Reply of Pre-Bid Queries for Design, Supply, Construction, Installation, Testing, Commissioning and Operation & Maintenance for 5 (five) years of Seamless Innovative Urban Transportation (Ropeway, Lifts & Escalators Etc.) Network in Shimla City (Himachal Pradesh) on Engineering Procurement and Construction (EPC) Mode.

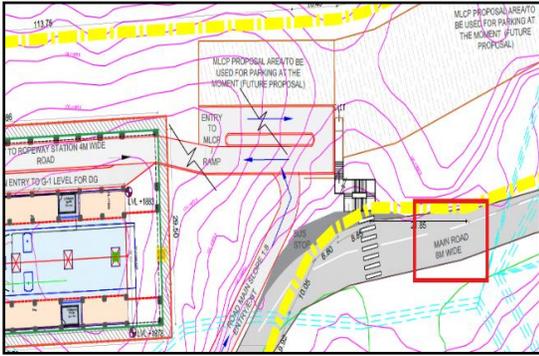
12	Structural Steel Grade - Outline Construction Specifications for Civil Works, Clause-10.10.1 Structural Steel, Page.No 198 Tender Drawings, Appendix B: Tower Foundation Drawings, Page No 21	Outline Construction Specifications for Civil Works 10.10 MATERIALS 10.10.1 Structural Steel. All structural components other than purlins and side cladding runners shall be made from Hot Rolled Sections and plates with Grade-B0 (with mandatory impact testing) having a minimum yield stress of 250 Mpa conforming to IS:2062. The minimum metal thickness for Hot Rolled sections shall be 6mm. Such steel shall be procured from approved manufacturers. TOWER FOUNDATIONS NOTES: 12. All steelwork will conform to BS 4449 or similar international standards. Billet and rolling mill records will be provided as part of the as built records. No cutting, welding or drilling will be permitted on site.	There is discrepancy in the requirement of grade of structural steel in the reference clause of Outline Construction Specifications for Civil Works and reference Notes of drawings. Kindly clarify. However, we request you to allow Indian standards grades of structural steel such as E350B0 or E410 grade, for towers.	This is an EPC contract in which design and grade of structural steel is to be evolved by the designer of the contractor and the Contractor is free to use higher grade or equivalent as per the availability, good industry practice and latest codes and specification with the approval of Authority.

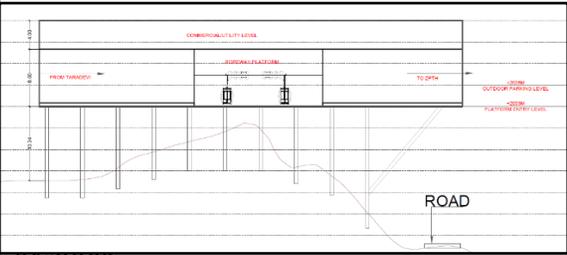
20	VUP overpass - OPERATION AND	2.1.3 The Contractor shall also maintain all access roads/overpasses/under-passes or other	We understand that the Contractor is supposed to only maintain the access roads/overpasses/under-passes or other	The contractor shall construct these facilities as part of the EPC work and maintain these

MAINTENANCE , Clause 2.1.3, Page No- 10	structures leading to the ropeway building from the main road.	structures leading to the ropeway building from the main road and the construction of the same is not in Contractor's scope. Kindly confirm.	during the O&M phase of the project. The alignment and Approach are available in Site Plans of Stations. Please Refer Appendix C.
			Kindly provide the location and alignment drawings and details of the existing access roads/overpasses/under-passes or other structures leading to the ropeway building from the main road for the ease of working out the maintenance cost and to avoid speculative bidding.	The Indicative Bid Drawings are already shared.
21	Work area, Land for Batching plant setup & Dumping yard - General, Functional, Design, Construction and Appendices, Clause 2.7, Page No.32	2.7 CONSTRUCTION YARD & DUMPING AREA Land required for construction yard, batching plant and other activities shall be arranged by the contractor and this land should be good for such offsite activities as needed by the Contractor at no extra cost to the Authority.	The Authority is better positioned to secure the required clearances and permissions from all the concerned departments. Therefore, the Authority is requested to acquire the necessary area of land for Construction yard and batching plant within maximum lead of 20 km from the project location with all the clearances and permissions from the relevant authorities.	Bid Conditions shall prevail. Dumping of excavated earth shall be done at respective site only and the space for the construction yard, Batching plant and other activities shall be identified by the Bidders and the cost of the same shall be borne by them.

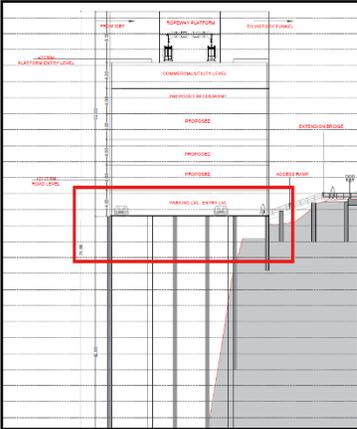
22	Approach road - Temporary Road access for Construction of Towers & Station Foundation	-	We understand that the Authority will provide the hinderance free land for temporary Access Road for construction of Towers and Stations. Please confirm.	Bidder understanding is right. The Authority will provide the hinderance free land for the construction of temporary Access Road.
23	Concrete Pump - RFP ANNEX – XIX TO APPENDIX IA: List of Minimum Construction	11. Equipment Type - Concrete Pump Total nos. - 2 Required Capacity - 180 cum/Hr	There appears to be a typographical error in the given requirement of Concrete pump capacity of 180 cum/ hr which seems to be on much higher side . Kindly check.	Required capacity for Concrete pumps is reduced as under - 30m ³ per hour Total numbers = 6.

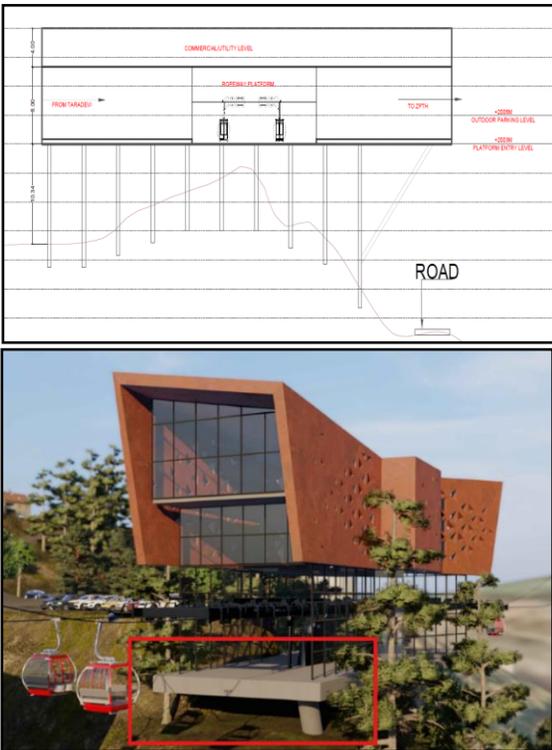
Equipment's to be deployed (owned/hired) by the bidder Page no. 101			
24	Mobile batching plant - RFP ANNEX – XIX TO APPENDIX IA: List of Minimum Construction Equipment's to be deployed (owned/hired) by the bidder Page no. 101	14. Equipment Type - Concrete Mobile Batching & Mixing Drum Plant Total nos. - 1 Required capacity - 20 cum/Hr	There appears to be a typographical error in the given requirement of Concrete Mobile Batching & Mixing Drum Plant capacity of 20 cum/ hr which seems to be on much higher side. Kindly check.	It has been checked and found correct.
25	Tree cutting Permission for temporary access road - General, Functional, Design, Construction and Appendices, Clause 2.1.A (xiii) page no. - 23 General, Functional, Design, Construction and Appendices, (Under 8.	(xiii) Necessary permission/ NOC from Forest/Railway/ Road and other concerned regulatory authorities for block and working in such locations. Authority will facilitate for getting them permission from concerned regulatory authorities for working in such locations. Necessary documents w.r.t tree cutting permission including land for compensatory forestation shall be ensured by Authority. (6) TREES The felling of trees in Shimla is governed by the GoHP Act “The Himachal Pradesh Private Forests Act, 1954”. The Contractor is not permitted to cut any trees without the permission of the Authority. The Authority has assessed the number of trees existing within the right-of-way and Stations, and necessary documents w.r.t tree cutting permission including land for compensatory forestation shall be ensured by	There is discrepancy in the reference clause regarding the permission for tree cutting. We understand that the Authority is better positioned to secure the required clearances and permissions from all the concerned departments. Therefore, the Authority is requested to take the necessary steps to obtain these clearances and permissions from the relevant authorities. Further, it is understood that in case of any delay in obtaining requisite clearances/permissions from the relevant Authorities, the Appointed Date would not be declared and the Contractor would be entitled to additional actual cost incurred on account of idling of deployed resources.	The authority i.e. RTDC, will obtain all tree cutting and other permissions. However, for expediting the project the Tree cutting and handing over of trees to relevant statutory bodies will be the responsibility of the Contractor.

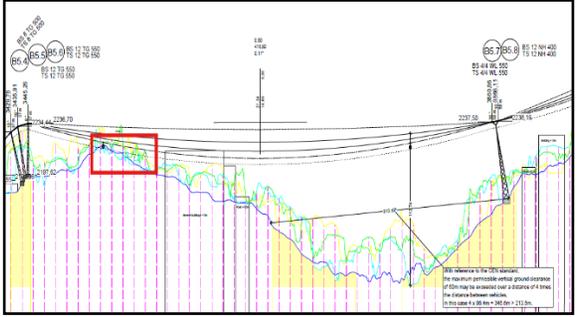
<p>29</p>	<p>Station Shifting - Tender Drawings, Appendix C: Architectural Drawings & 3D Views of Stations</p>	<p>Station section below showing the cantilever portion of station.</p> 	<p>As per cross-sectional view of reference drawing, majorly all the stations have maximum portion of station as cantilevered portion which is quite a task to design and execute.</p> <p>Therefore, we request the Authority to allow relevant shifting of the station towards flat terrain in order to optimize cost factors and to enhance safety provisions.</p>	<p>This is an EPC contract. The Contractor is responsible for carrying out all designs. The bid drawings are for indicative purposes only.</p>
-----------	--	---	--	--
